Access Compliance Report

Public Rights-of-Way

(Curb Ramps)

Intersection ID: 11898	Main Street: ALLEN_ST	Cross Street: E_18TH_ST	Location: S
ADA ID: 1F08C0F12081	Ramp Type: PerpDiag	Initial Pass/Fail: Fail	Overall Compliance: No
Severity Score: 1.25			
Codes/Mitigation Info/Possible Solution		Field Measurements/Component Compliance

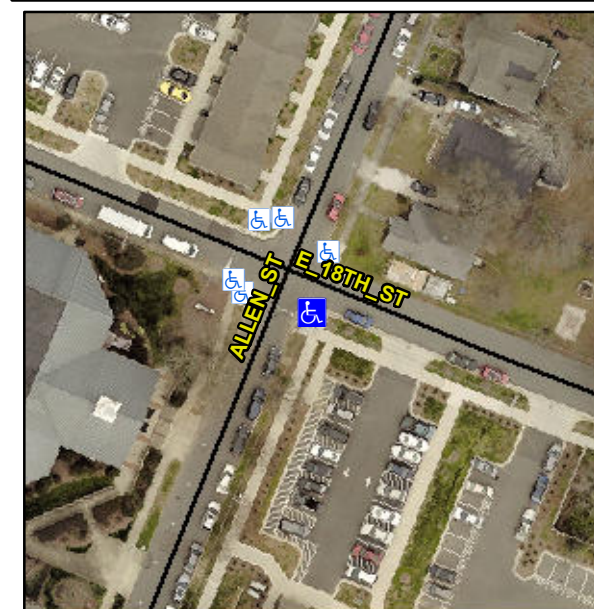
R304.5.3

Compliance	Description	Data	Compliance	Description	Data
N/A	Ramp Length (in)	92.5	Yes	Ramp Slope (%)	8.2
Yes	Ramp Width (in)	50.5	No	Ramp XSlope (%)	2.8
N/A	Flare Type LT	N/A	N/A	Flare Type RT	N/A
N/A	Flare Slope LT (%)	N/A	N/A	Flare Slope RT (%)	N/A
N/A	Flare Traversable LT?	N/A	N/A	Flare Traversable RT?	N/A
N/A	Landing Length (in)	N/A	N/A	DWS Provided?	N/A
N/A	Landing Width (in)	N/A	N/A	DWS Contrast?	N/A
N/A	Landing Slope (%)	N/A	N/A	DWS Length (in)	N/A
N/A	Landing X Slope (%)	N/A	N/A	DWS Full Width?	N/A
N/A	Landing Curb? (Y/N)	N/A	N/A	DWS Offset (in)	N/A
N/A	Shared Landing?	N/A			
N/A	Gutter Ponding?	Yes	N/A	Gutter Slope (%)	N/A
N/A	Gutter Lip Ht (in)	N/A	N/A	Gutter X Slope (%)	N/A
N/A	Painted X Walk1?	No	N/A	Painted X Walk2?	No
	X Walk 1 Direction	To NE		X Walk 2 Direction	To NW
N/A	X Walk 1 Width (in)	N/A	N/A	X Walk 2 Width (in)	N/A
	X Walk 1 Slope (%)	1.5		X Walk 2 Slope (%)	1.7
	X Walk 1 X Slope (%)	3.4		X Walk 2 X Slope (%)	0.0

Remove & Replace Curb Ramp With Two New Directional Ramps or Equivalent.
